Wellington Solar Farm (Mod 1)

*State Significant
Development
Modification Assessment
(SSD 8573 MOD 1)*

December 2019

Figure 2 | Proposed Modification

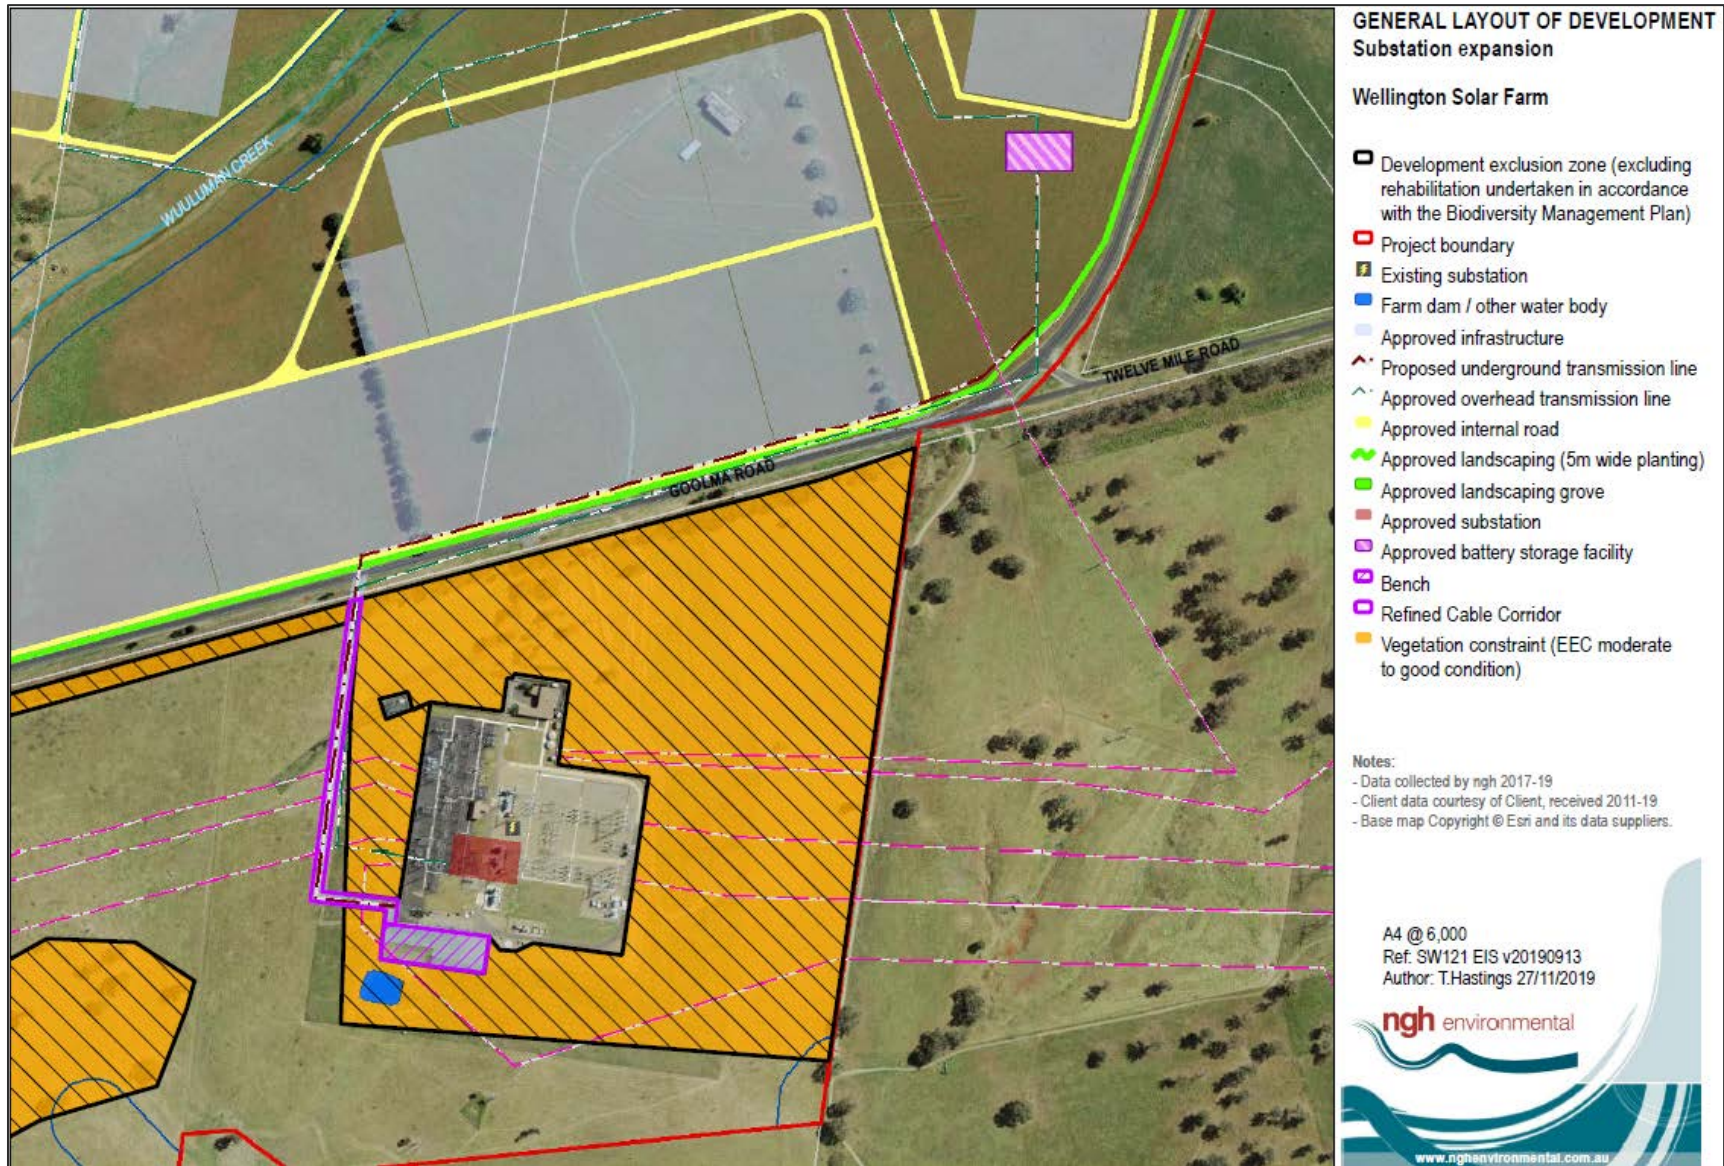
The proposed underground transmission line generally follows the alignment of the approved overhead line. However, the proposed underground line would run parallel to Goolma Road underneath an internal access road within the development footprint (as opposed to within the Goolma Road road reserve), before it crosses Goolma Road towards to substation.

South of Goolma Road the underground transmission line would follow the approved overhead line alignment but would extend by approximately 110 m (i.e. the length between the approved and proposed connection points).

Despite this extension, the proposed underground transmission line would be longer by approximately 5 m (i.e. 1,275 m). The difference is due to the proposed realignment between the energy storage facility and the crossing of Goolma Road, which would make this section of the proposed transmission line shorter.

Figure 4 | Vegetation Community Zones within the Proposed Modification

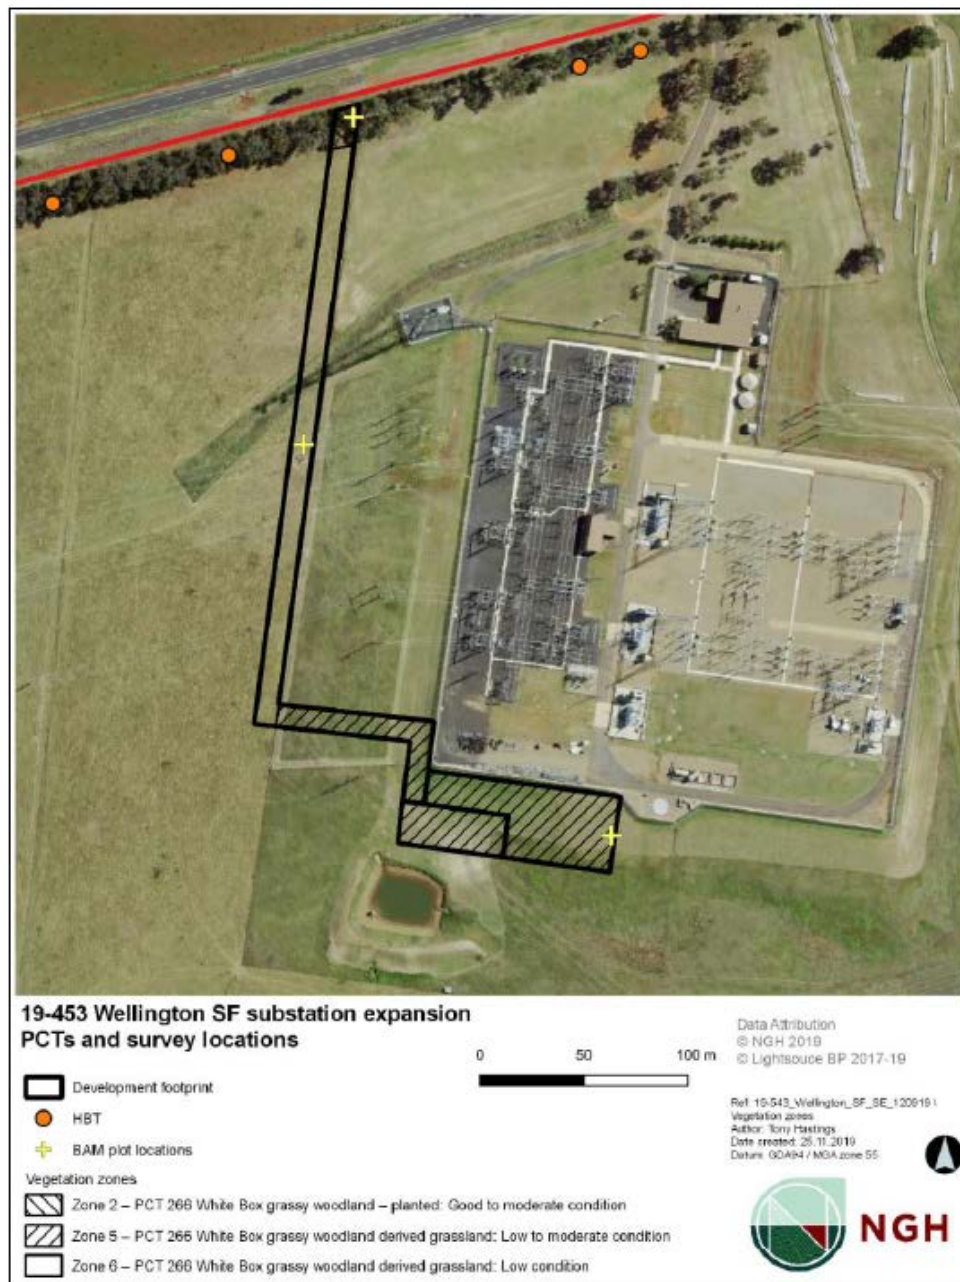
designed to minimise the impacts to native vegetation, it would still impact 0.78 ha, including 0.02 ha of EEC in moderate to good condition. The impacts to each zone are specified in **Table 1** and **Figure 4**.

Under the NSW Biodiversity Offsets Scheme, the clearing of EEC in moderate to good condition (zone 2) would increase the project's offset requirements by an additional ecosystem credit (from 3 as originally approved to 4 required after this modification). The impacts to the other two zones (zone 5 and zone 6) would not generate any additional ecosystem credits due to the low condition of the vegetation.

In addition, the entire area of impact (0.78 ha) has been assessed as suitable habitat for the Pink-Tailed Legless Lizard which is a threatened species under the BC Act. Although a fauna survey was not undertaken, the species was assumed to be present. Therefore, this resulted in two species credits (meaning a total of two species credits is now required for the project).

Both the Department and the BCD are satisfied that the modification would not result in any significant biodiversity impacts, subject to the provision of the updated offset liability credits.
